Saturation energy density
for laser stripping via a broad Stark state

Isao Yamane, KEK

Comments from Dr. A. Hershcovitch

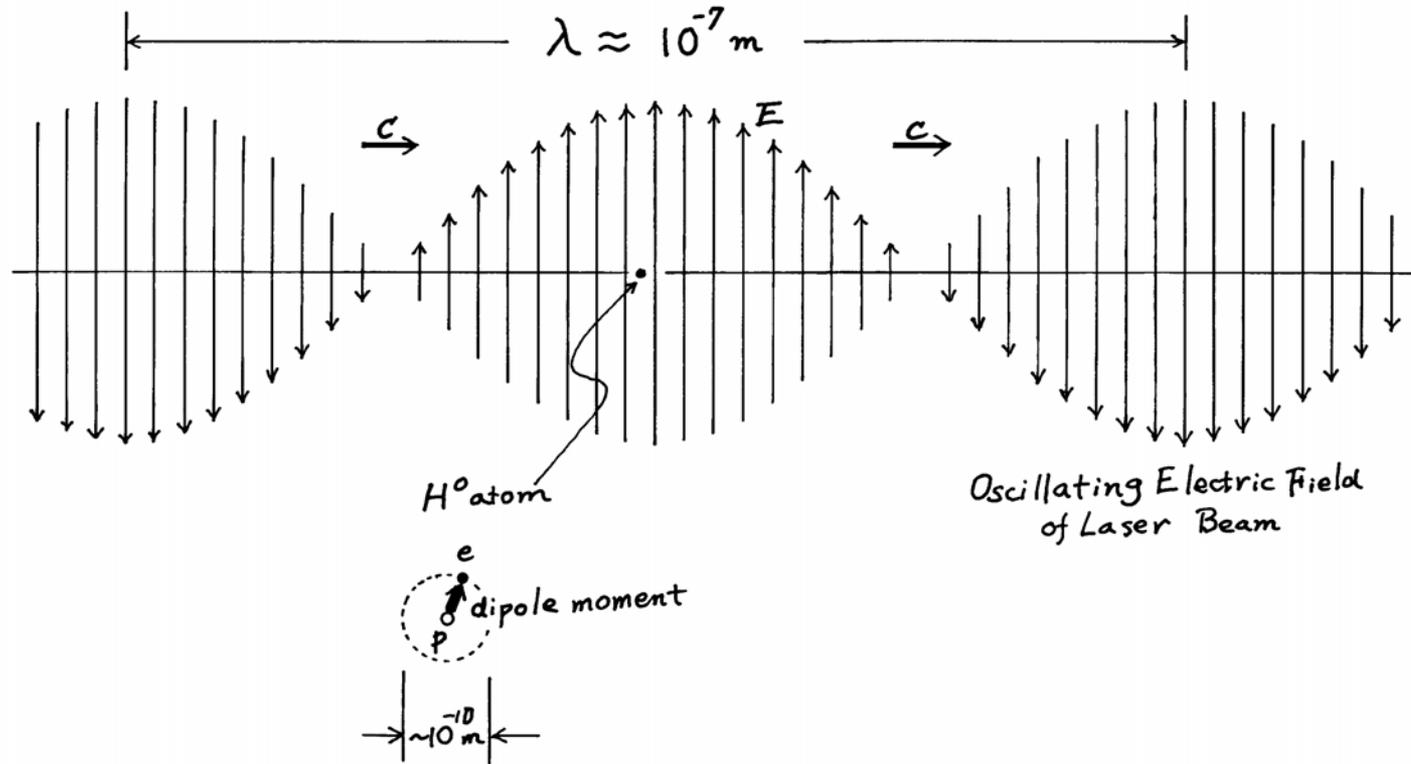
On October 27, 2003, Brant Johnson and I met with Howard Bryant from the University of New Mexico to discuss Yamane's proposal and planned experiments. Prior to the meeting, I had two major issues with Yamane's proposal and planned experiments:

1. I had doubts about the validity equation 8 in Yamane's KEK report 2002-76 (on page 6). In equation 8, the laser energy density needed to photodetach H zero is reduced by a factor equal to the product of the line width of the transition and the interaction time in the particle rest frame. The consequence of this equation is rather critical: the laser power necessary for photodetachment is reduced by three orders of magnitude.
2. In Yamane's POP experimental proposal, photodetached protons are to be detected by a Faraday cup. If the equation 8 enhancement factor does not materialize, nothing (other than noise) would be detected by the Faraday cup.

1. It's a very interesting experiment; it is definitely worth performing.
2. Regarding my first concern, it is not clear that equation 8 is valid. That equation is based on equation 3.18 (on page 77) from Letokhov's book titled "Laser Photo ionization Spectroscopy." Brant and Howard expressed a major concern regarding the applicability of equation 3.18 to Yamane's case, since derivations and discussions in the book leading to this equation involve multi-electron systems. Hence it might not be applicable to the hydrogen atom.

3. Regarding my second concern, Brant and Howard suggested using a scintillator if the Faraday cup cannot detect the proton signal. Therefore, photodetached protons can be detected even if the yield is very small.

4. Concern was raised about the experiment being a true POP for SNS, since foil stripping is not equivalent to the magnetic stripping proposed for SNS. The former results in excited atoms, which later can lose the extra electron by other processes.

5. One must examine lifetime of the expected excited states in their flight path (including the magnetic fields).
6. A suggestion was made to use a laser in the first step as well.

7. A movable **detector** should be used after the first bending magnet, since it was found experimentally that excited hydrogen trajectories are smeared due to various stripping mechanisms. Basically, **one should study trajectories of the foil-detached atoms well**, before proceeding to photodetach them.

Regarding item 5, it is advisable to consult Keating et. al PRA 55, 4547 (1995). And for item 7, one must consult Gulley et. al PRA 53, 3201 (1996) especially figures 5&6; as well as Keating et al PRA 58, 4526 (1998) especially figure 5. Finally, it would be advisable to invite Brant and Howard to attend the next meeting with Yamane.
